TRANS/WP.29/963  
23 January 2004

World Forum for Harmonization of Vehicle Regulations (WP.29)

CORRIGENDUM 1 TO SUPPLEMENT 15 TO THE 04 SERIES  
OF AMENDMENTS TO REGULATION No.16

(Safety belts)

**Figure 1** – ISO/F3 envelope dimensions for a full-height forward-facing toddler CRS (height 720 mm) - ISOFIX SIZE CLASS A

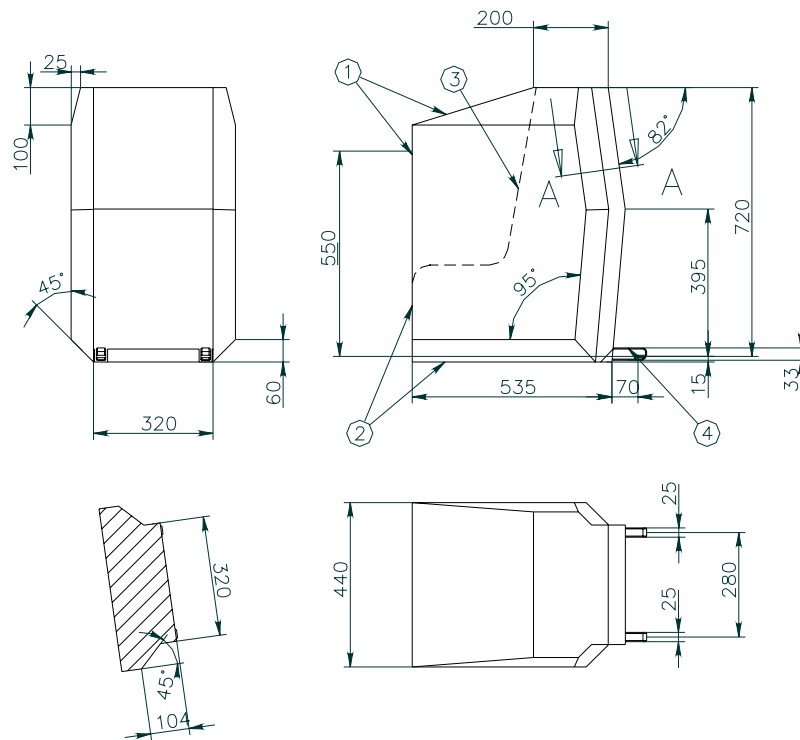
Paragraphs 4.1. and 4.2., amend to read:

"4.1. Full-height forward-facing toddler child restraint systems envelope

**Figure 2** – ISO/F2 envelope dimensions for a reduced-height forward-facing toddler CRS, (height 650 mm) – ISOFIX SIZE CLASS B"

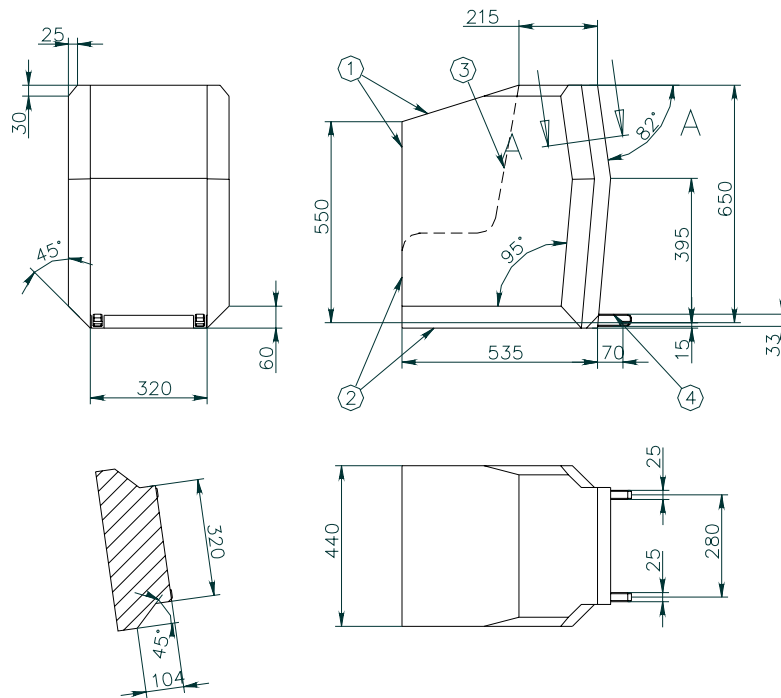
## 4.2. Reduced-height forward-facing toddler child restraint systems envelope

Figure 3 – ISO/F2X envelope dimensions for a reduced-height second version back surface shape forward-facing toddler CRS, (height 650 mm) – ISOFIX SIZE CLASS B1"

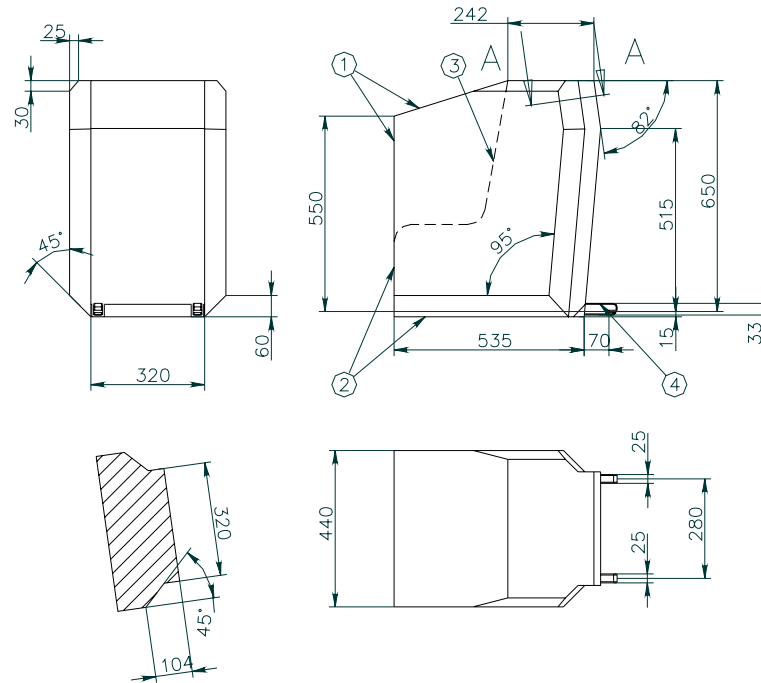
Insert a new paragraph 4.3., to read:

"4.3. Reduced-height second version back shape forward-facing toddler child restraint systems envelope

**Figure 4** – ISO/R3 envelope dimensions for a full-size rearward-facing toddler CRS – ISOFIX SIZE CLASS C

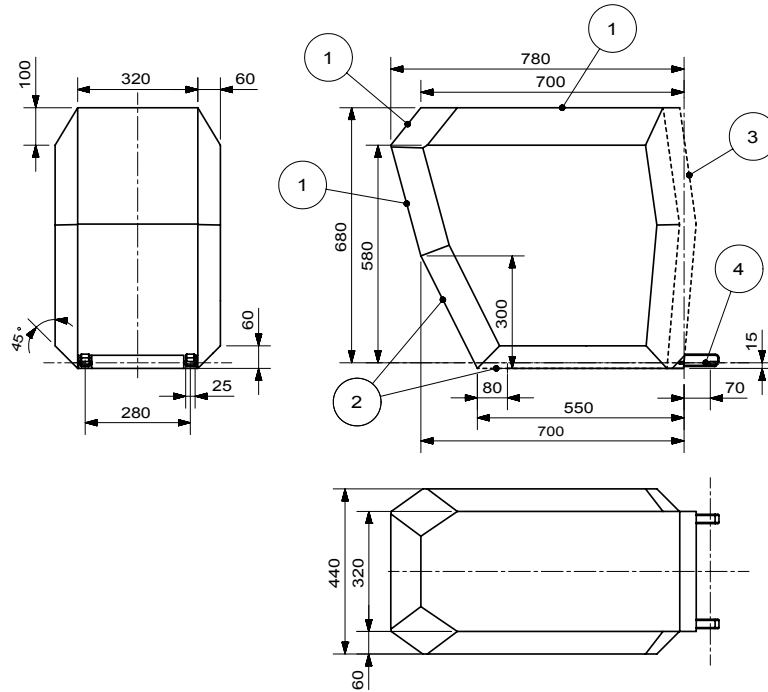
Paragraphs 4.3. to 4.6. (former), renumber as paragraphs 4.4. to 4.7., and amend to read:

"4.4. Full-size rearward facing toddler child restraint system envelope

- 1 Limits in the rearward and upwards directions
- 2 Dashed line marks area where a support leg, or similar, is allowed to protrude
- 3 The backwards limitation (to the right in the figure) is given by the forward-facing envelope in Figure 2
- 4 Further specifications of the connector area is given in Regulation No. 44

Figure 5 – ISO/R2 envelope dimensions for a reduced-size rearward-facing toddler CRS – ISOFIX SIZE CLASS D

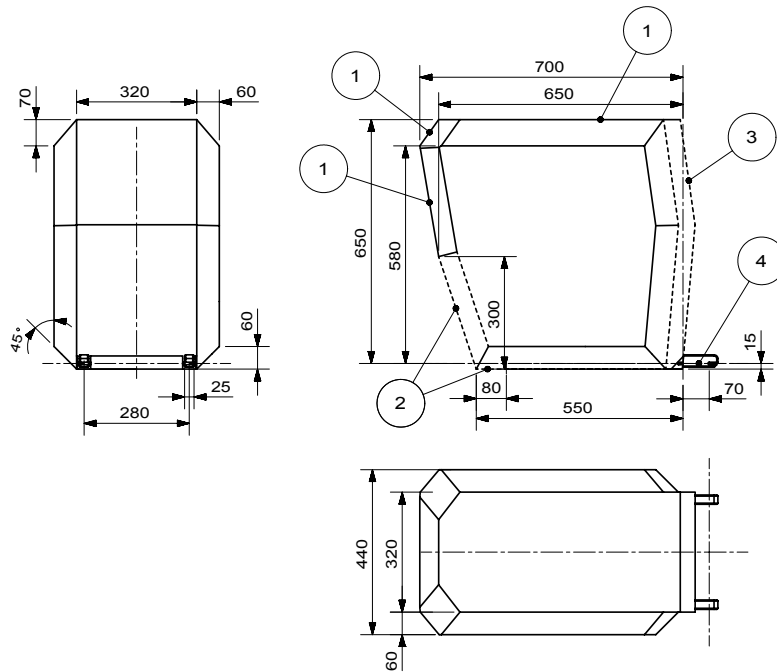
4.5. Reduced-size rearward-facing toddler child restraint systems envelope

- 1 Limits in the rearward and upwards directions
- 2 Dashed line marks area where a support leg, or similar, is allowed to protrude
- 3 The backwards limitation (to the right in the figure) is given by the forward-facing envelope in Figure 2
- 4 Further specifications of the connector area is given in Regulation No. 44

**Figure 6** – ISO/R1 envelope dimensions for an infant-size rearward-facing CRS – ISOFIX SIZE CLASS E

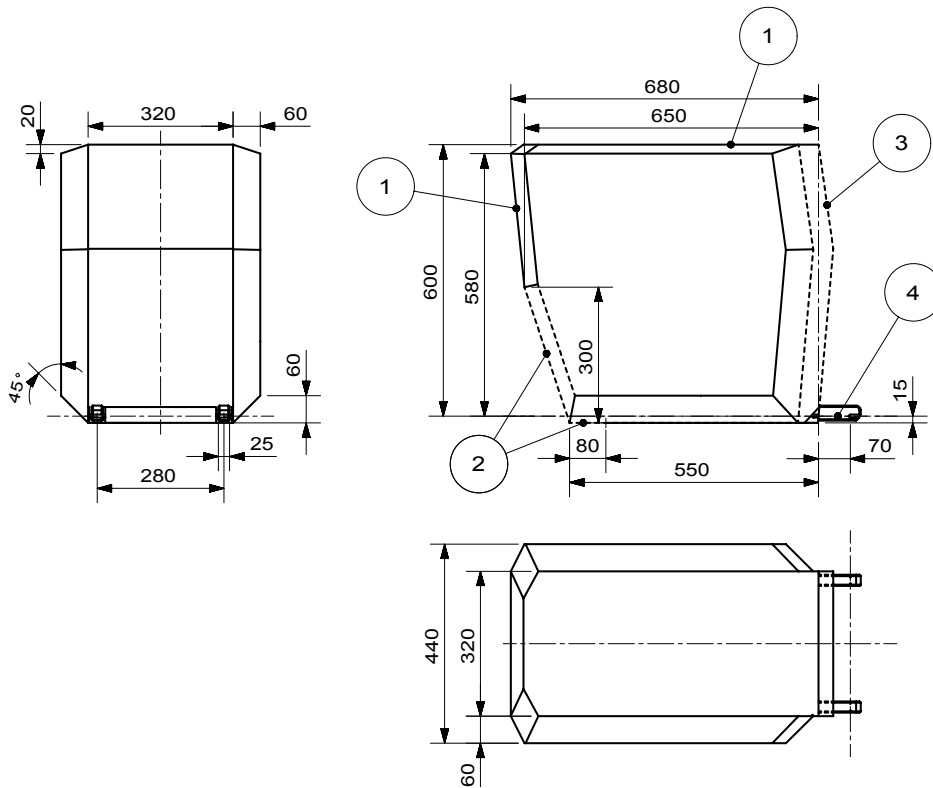
4.6. Rearward facing infant child restraint systems envelope

Figure 3 RF 1 Revised

- 1 Limits in the rearward and upward directions
- 2 Dashed line marks area where a support leg, or similar, is allowed to protrude
- 3 The backwards limitation (to the right in the figure) is given by the forward-facing envelope in Figure 2
- 4 Further specifications of the connector area is given in Regulation No. 44

Figure 7 – Envelop dimensions for lateral facing position CRS - ISO/L1-ISOFIX SIZE CLASS F or symmetrically opposite – ISO/L2 – ISOFIX CLASS G"

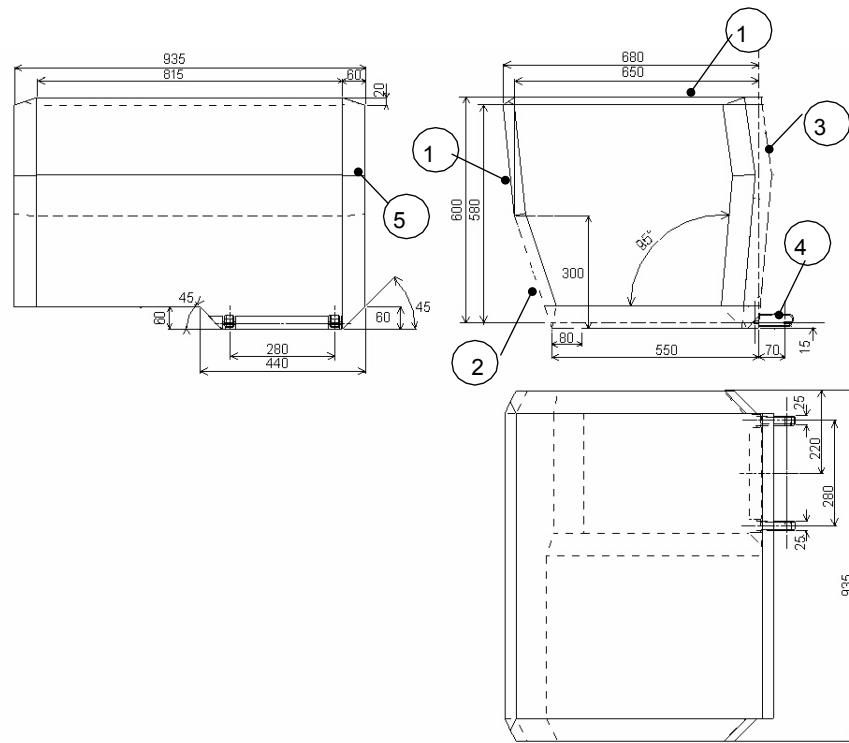
4.7. Lateral facing child restraint systems envelope

- 1 Limits in the rearward and upward directions
- 2 Dashed line marks area where a support leg, or similar, is allowed to protrude
- 3 The backward limitation (to the right in the figure) is given by the forward-facing envelope in Figure 2
- 4 Further specifications of the connector area is given in ISO 13216-1, Figures 2 and 3
